CERTIFICATE OF APPROPRIATENESS				
Applicant:	Hossein Taghi, owner and Sati Yusek, agent				
Property:	4031 Norhill Blvd, LT 4, Block 126, North Norhill. The property includes a 1,140 SF residence and detached garage on a 5,000 SF lot.				
Significance:	This is bungalow duplex was constructed circa 1930, located in the Norhill Historic District.				
Proposal:	 Alteration – Addition. Single-story addition of 771 sq ft resulting in a total of 1,911 sq ft of living space. Both sides of addition are inset from original corners. 122 (20'3" x 6') sq ft covered porch on south side addition, set back from original corners. Total footprint including porches will be 2,231 sq ft. Rear/west setback of 4' – North (right side) elevation is set back 3'-10" and are fire rated. South (left side) elevation is maintained at 17'-10" Inset and recessed wood windows on addition will match historic appearance. Reof pitch on addition to match historic gable with asphalt shingles, existing shingle roof replacement with like material (exempt). Smooth Cementitious siding on addition. Fascia and rafters on addition to match existing, historic dimensions. Salvage, patch, and repair original wood siding (exempt

I. PROPOSED EAST ELEVATION

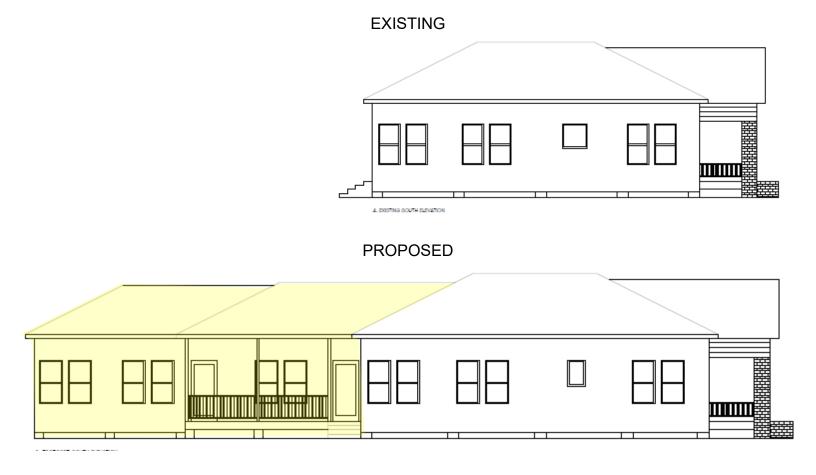
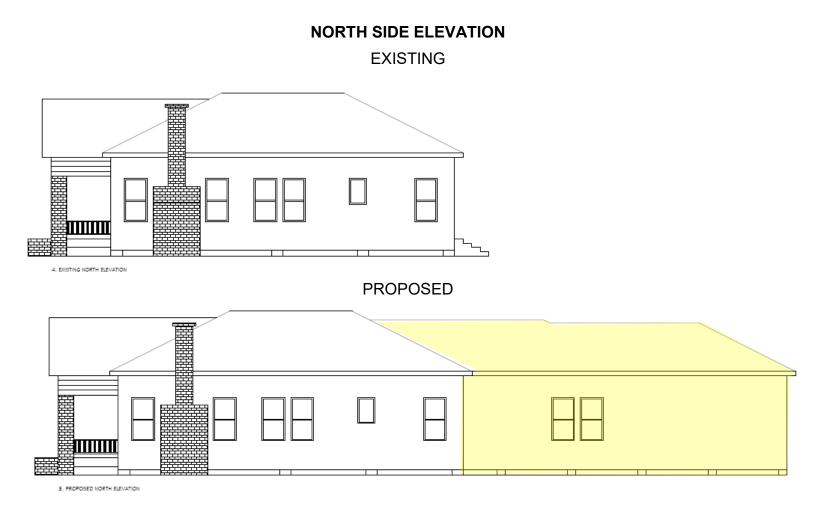
No Changes to front elevation in what is proposed - work with staff once non-original siding is removed
